Project	<b>IEEE 802.16 Broadband Wireless Access Working Group</b> < <a href="http://ieee802.org/16">http://ieee802.org/16</a> >	
Title	<b>Consistent MAC Header Extendibility Mechanisms</b>	
Date Submitted	<b>2005-03-17</b>	
Source(s)	16e session#36 MAC Header Drafting Group	Voice: 760-448-4168 Fax: 760-448-1989 <a href="mailto:lwang@cygnuscom.com">lwang@cygnuscom.com</a>
Re:	This contribution proposes additional capabilities for 802.16e	
Abstract	[Description of document contents.]	
Purpose	The purpose of this contribution is to define flexible extension mechanism for MAC sub header	
Notice	This document has been prepared to assist IEEE 802.16. It is offered as a basis for discussion and is not binding on the contributing individual(s) or organization(s). The material in this document is subject to change in form and content after further study. The contributor(s) reserve(s) the right to add, amend or withdraw material contained herein.

# Consistent MAC Header Extendibility Mechanisms

## *Session#36 MAC Header Drafting Group*

Figure XXa: Format of Extended header

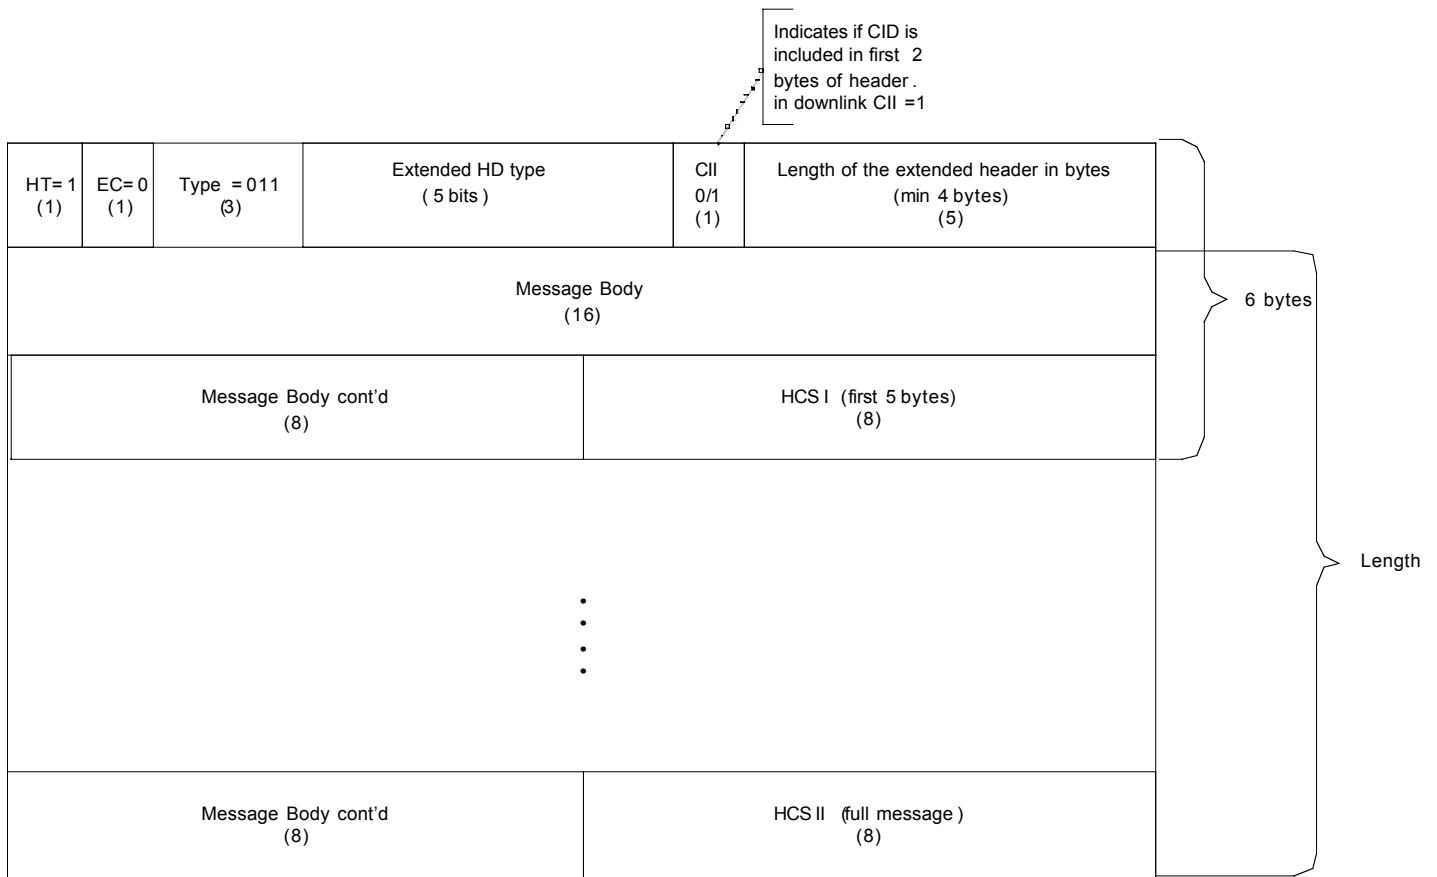
1. *Page 26, line 40, insert the following:*

#### 6.3.2.1.7 Extended MAC Header

The format of Extended MAC Header is shown in figure x1.

The Extended MAC header shall have the following properties:

- a) The size of the Extended MAC header message shall be defined by the field of Length of the extended header.
- b) The EC field shall be set to 0, indicating no encryption.
- c) The CII field (CID Inclusion Indication) shall be set to 1 for the header with CID field and set to 0 for the header without CID field.
